#### CALIFORNIA COASTAL COMMISSION SOUTH COAST DISTRICT OFFICE

### ADDENDUM

## SUBJECT: ADDENDUM TO ITEM W14b&15a, APPLICATION NO. A-5-SNP-19-0136 & 5-20-0153 (Poola/1305 W Paseo del Mar) FOR THE COMMISSION MEETING OF WEDNESDAY, DECEMBER 15, 2021.

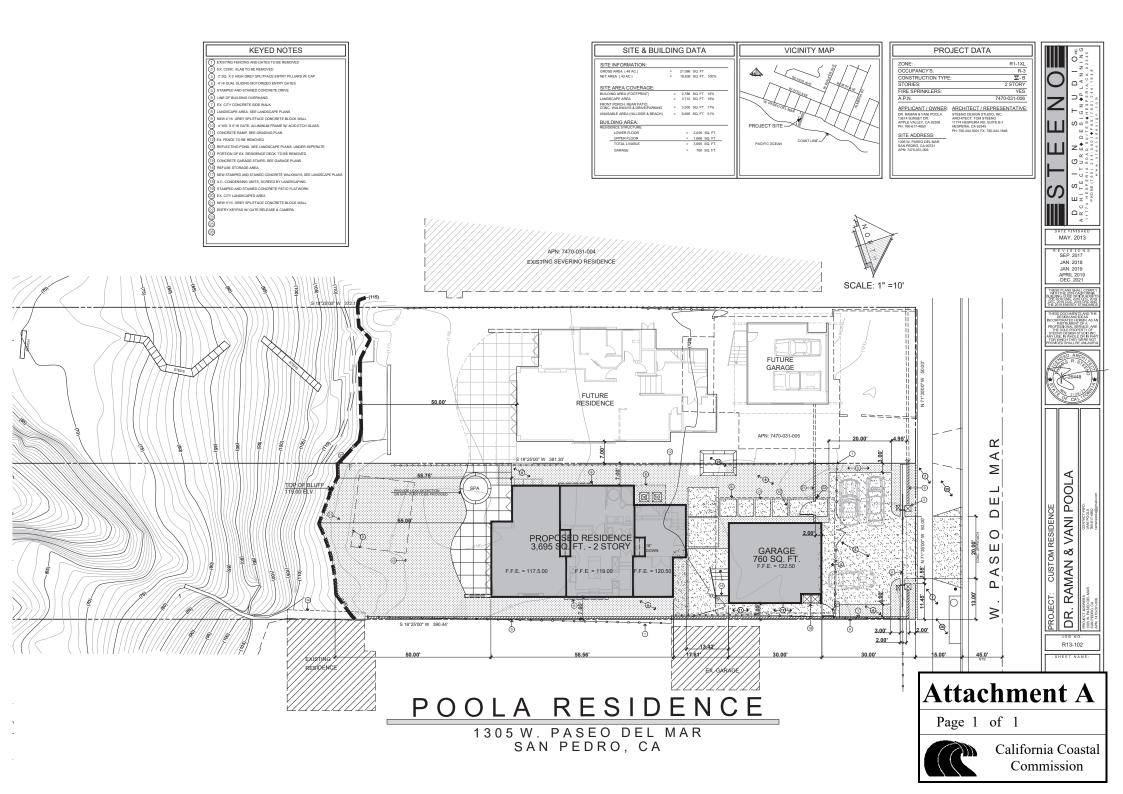
12) Other 2-story homes on the bluff are setback approximately 75 ft. The structure should either be modified to be a one-story home or be set back approximately 75 ft. from the bluff edge as are the other 2-story (heavier) homes along this bluff. Staff notes that most of the residences along this blufftop neighborhood are built closer to the bluff edge than the proposed projects. As discussed in the 12/3/2021 staff report, the proposed residences are set back at least 50 ft. from the bluff edge and are designed and conditioned to assure structural stability and protection of coastal resources.

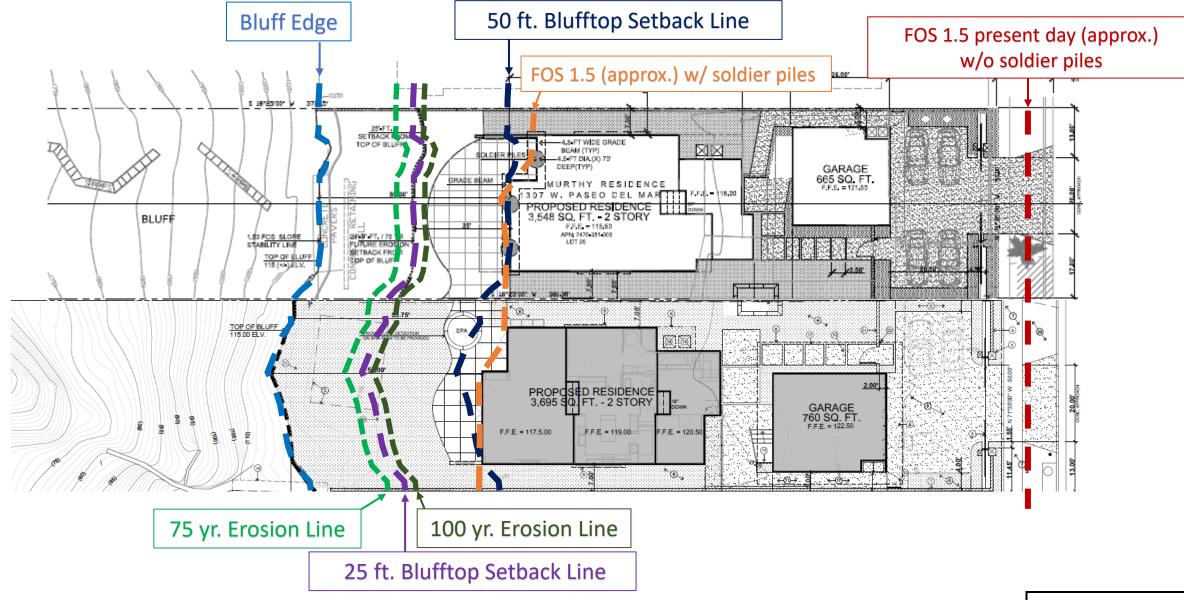
**13)** Two-lot compounds are not part of the character of this neighborhood. Staff acknowledges that the proposed residences share a similar design, and that there are shared landscaping features and no boundary wall between the two proposed residences. However, and as discussed, public blue water views from W Paseo del Mar along this blufftop neighborhood are currently restricted as homes, such as the proposed, are set back from the bluff and closer to the street. Staff believes the similarity of the two proposed homes does not pose a coastal resource concern.
